Cross River Rail Project

Coordinator-General's change report—Roma Street demolition works

March 2019

Figure 4.1 Stage one proposed vehicle access (Source: November 2018 project change application)

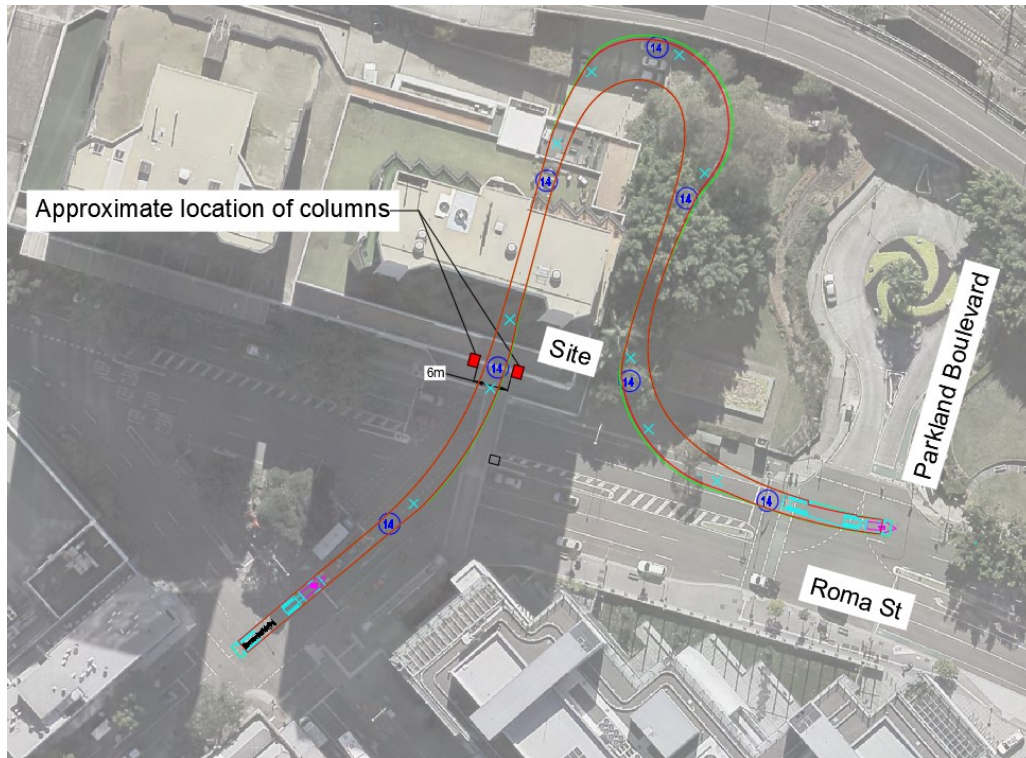
The proponent has indicated in their change application that access to the Roma Street demolition worksite would be provided from Roma Street in two stages. Stage one (refer to Figure 4.1) would include the demolition of the BTC east tower, during which vehicles would access the worksite from the northern end of Roma Street (the current access to Hotel Jen) via Herschel Street and exit through the open space park to Roma Street.

I note that access for demolition haulage vehicles was raised in a submission and the proponent in their response advised that the height clearance through Hotel Jen and the manoeuvres required to access the worksite have been tested and can be achieved.

Modifications to the grade of the open space adjacent to Hotel Jen is proposed to ensure heavy vehicles can safely access (exit) the site. As the open space is at a higher elevation than the road, some levelling would be required. The proponent has indicated that the exact modifications to the open space would be confirmed prior to the commencement of site works, once a survey of the site is completed.

Figure 4.2 Stage two proposed vehicle access to the Roma Street worksite (Source: November 2018 project change application)

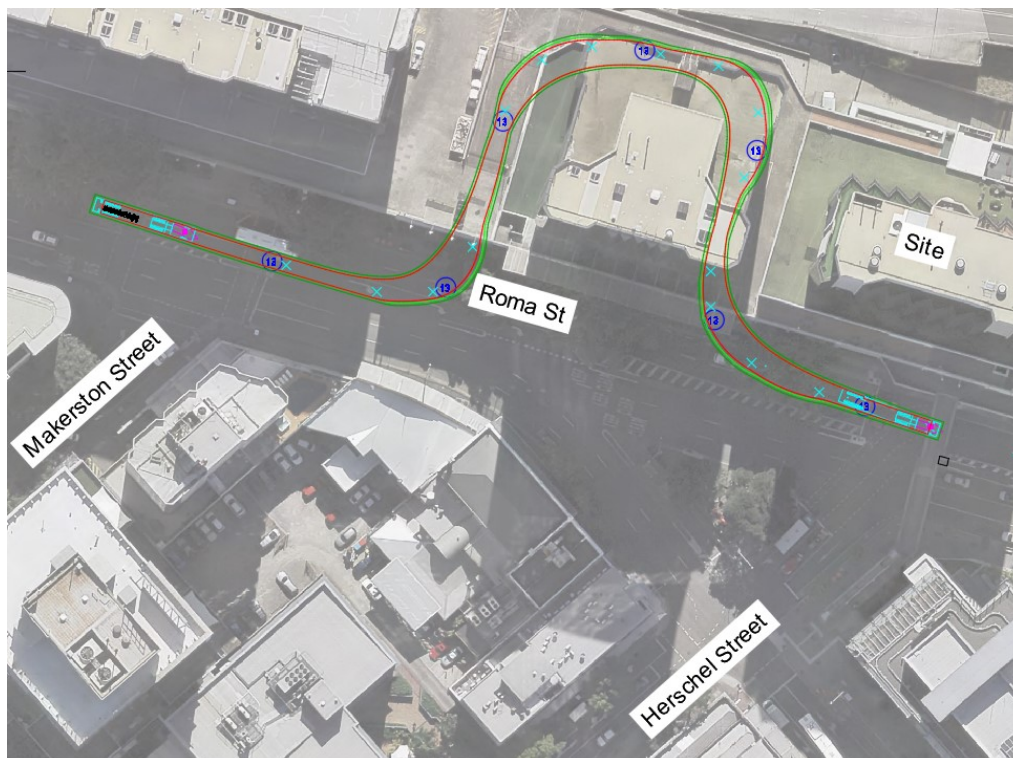
Stage two (refer to Figure 4.2) would include the demolition of Hotel Jen and would commence once the BTC east tower lot has been cleared.

Following clearance of the BTC east tower lot, demolition vehicles would access and exit the site via the BTC east tower lot.

Figure 4.3 Heritage values within and surrounding the Roma Street worksite (Source: proponent March 2019)

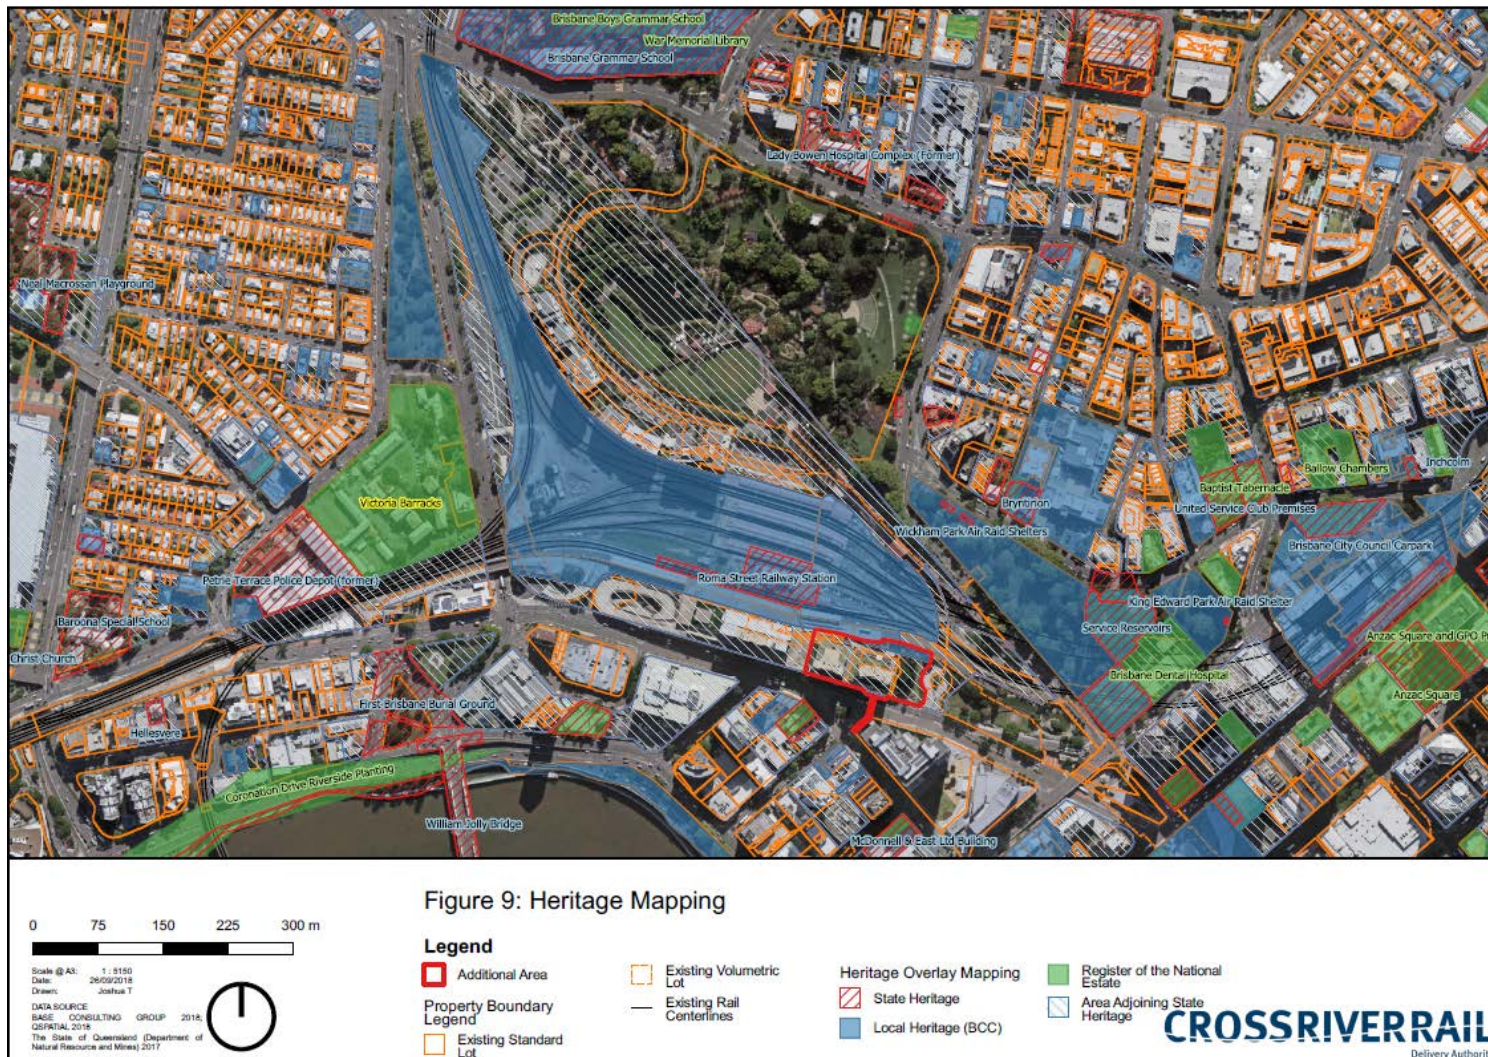
The proponent's assessment concluded that due to the large amount of open space required for the demolition worksites there may be some disturbance to locally heritage listed places near the proposed underground Roma Street station. The impact area for the Roma Street demolition works overlap with a portion of the locally listed Roma Street Railyards on Lot 35 Plan SP207219, shown on Figure 4.3.

The assessment also indicated that the proposed changes to the project at Roma Street may increase the possible disturbance or destruction of subsurface archaeological deposits due to the increase in disturbed surface area. This is particularly the case where excavation occurs within the demolition site and the relevant part of the Lot 60 area adjacent to Hotel Jen.

The proponent has advised that potential impacts to non-Indigenous cultural heritage would be detailed in the Non-Indigenous Cultural Heritage Management Plan and include the following mitigation measures:
